**REQUEST FOR APPROVAL OF
ALTERNATIVE WASTE MANAGEMENT PRACTICES
(Conventional Operations Only)**

Well Operator PENNHILLS RESOURCES, LLC		DEP ID/OGO No. 306870	U.S. Well No. (API No.) 053-31155	
Address PO BOX 426			Well Farm Name WT. 2850 LOT 1	
City MT. JEWETT	State PA	Zip Code 16740	Well No. 3	Serial No.
Telephone No. (814) 975-3009	Fax No. (814) 778-6874	County FOREST	Municipality HOWE TWP.

WT. 2850 Lot 1 – WELL #3

ATTACHMENT FOR ALTERNATIVE WASTE MANAGEMENT PRACTICES (CONVENTIONAL OPERATIONS ONLY)

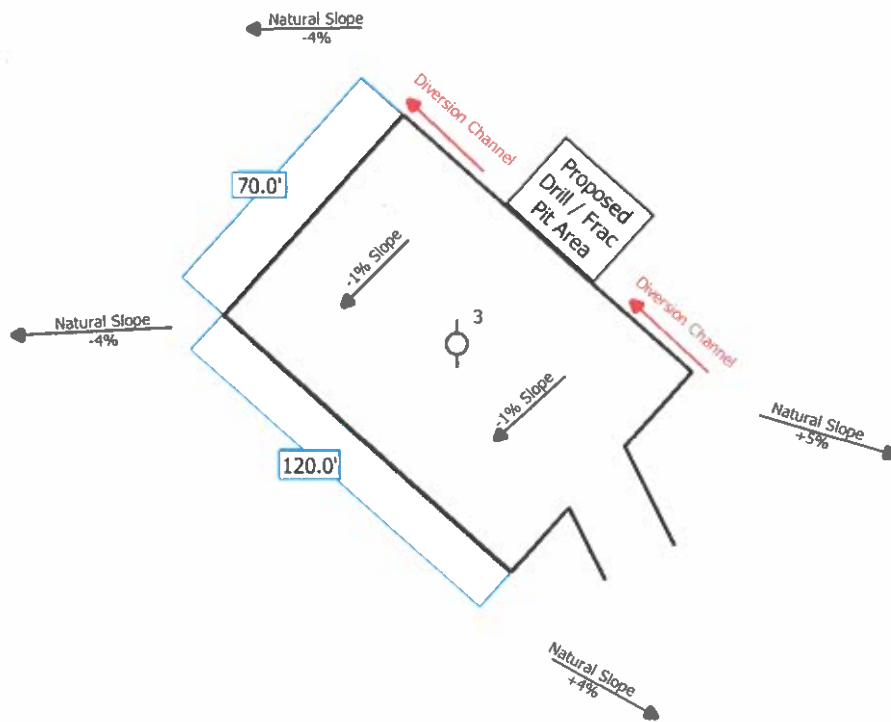
Conditions: A site evaluation determined that this site is unsuited for the proposed Alternate Waste Management Practices. The operator may resubmit the Request for Approval of Alternate Waste Management Practices if they can demonstrate that shallow groundwater will not compromise the drill pit on this well site.
